**ADDENDUM 01**

Addendum #	01	Date Issued	03/21/2025
Project Name Job #	SWN 0509, Waneta Hall Renovate Restrooms	OSE #	R0325--15X
		EAPC #	20256780
Bid Date Time	April 3, 2025		3:30pm

PROJECT DESCRIPTION
SWN 0509, WANETA HALL RENOVATE RESTROOMS (OSE# R0325--15X)

4 FIRST FLOOR PLUMBING PLAN - LAUNDRY (ALT. 02)
 P201 1/4" = 1'-0"

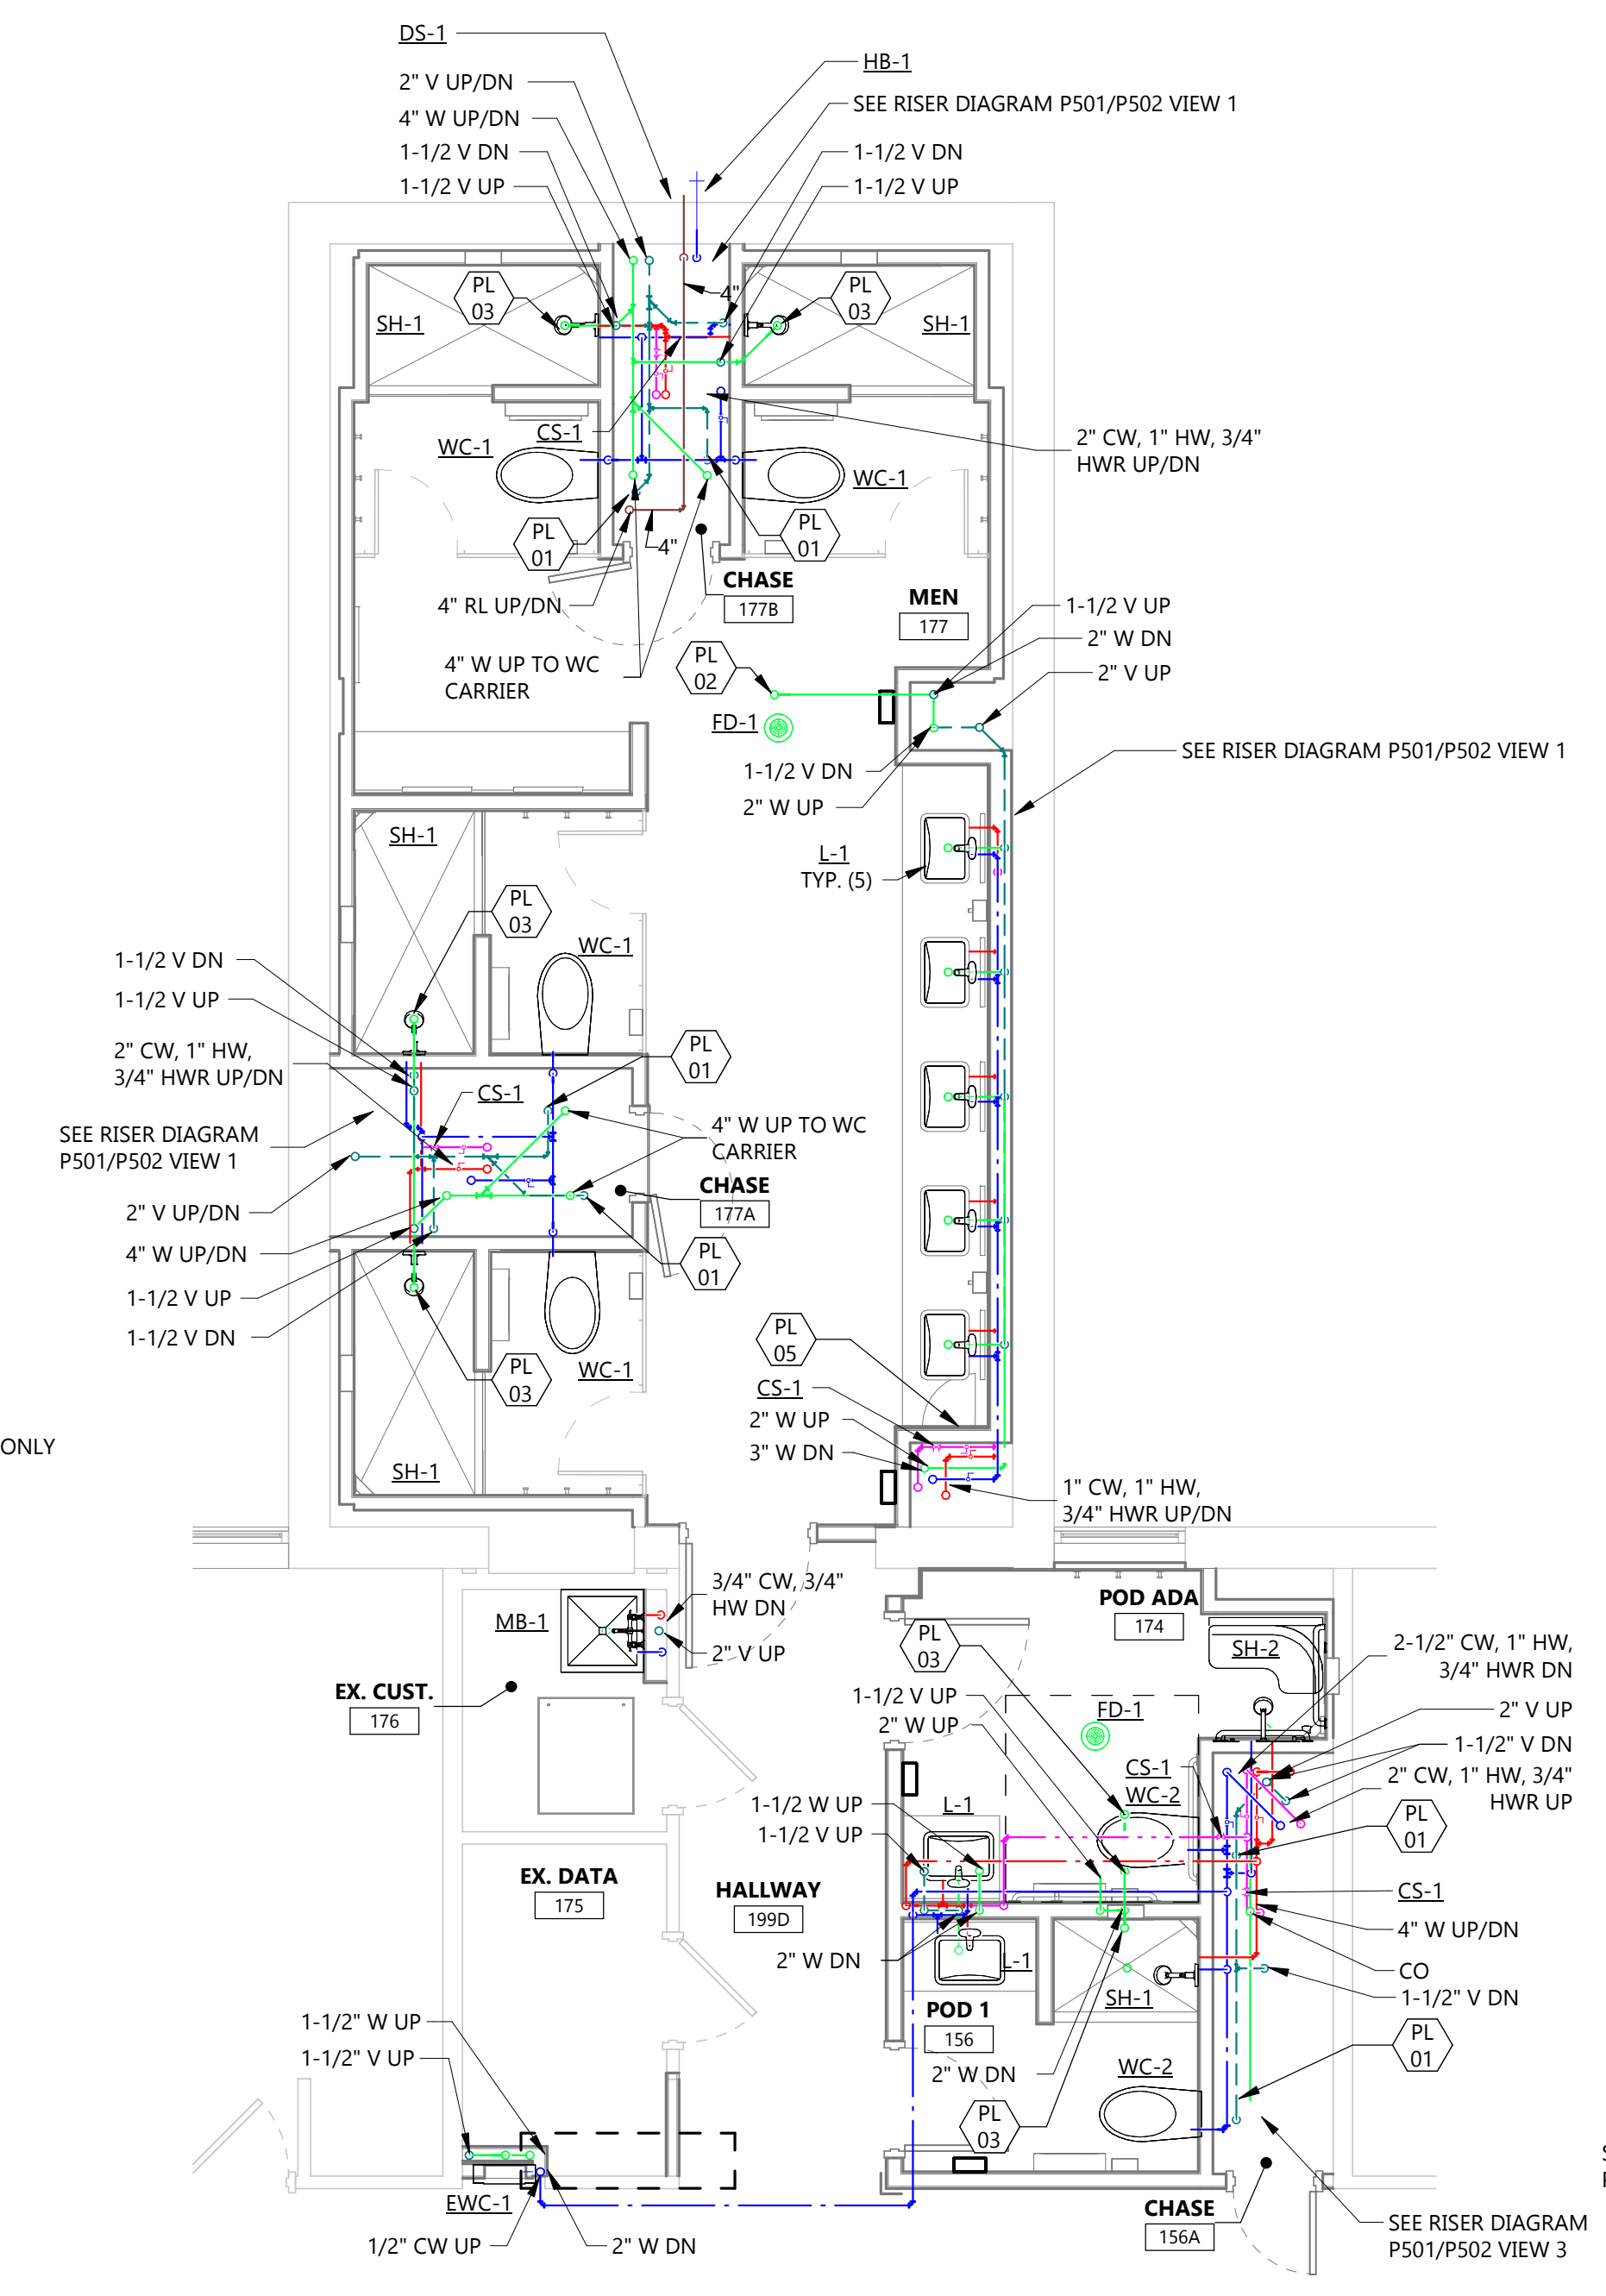
P200	REVISE plumbing pipe routing to stay within tunnel space regarding Alternate 02 work.
P201	REVISE plumbing pipe routing in wall associated with Alternate 02.
M201	REVISE ERU's and associated ACCU's locations for concrete pad and clearances.
M301	REVISE ERU and ACCU locations for concrete pad and clearances. ADD section view for ductwork installation.
E101	CLARIFIATION on existing panel names.
E102	CLARIFIATION on panel names.
E103	CLARIFIATION on panel names and demo at RM 326.
E200	ADD location for MDP.
E201	ADD location for mechanical equipment and duct smoke detectors. Add clarification on alternates. REVISE power at alternates ADD notes 5 and 6.
E202	ADD clarification on alternates. Add notes 3 and 4. REVISE power at Study rooms
E203	ADD note 4 for data rough in. Update power at Study rooms
E301	ADD clarification on lighting types and occupancy sensors.
E302	ADD clarification on lighting types and occupancy sensors.
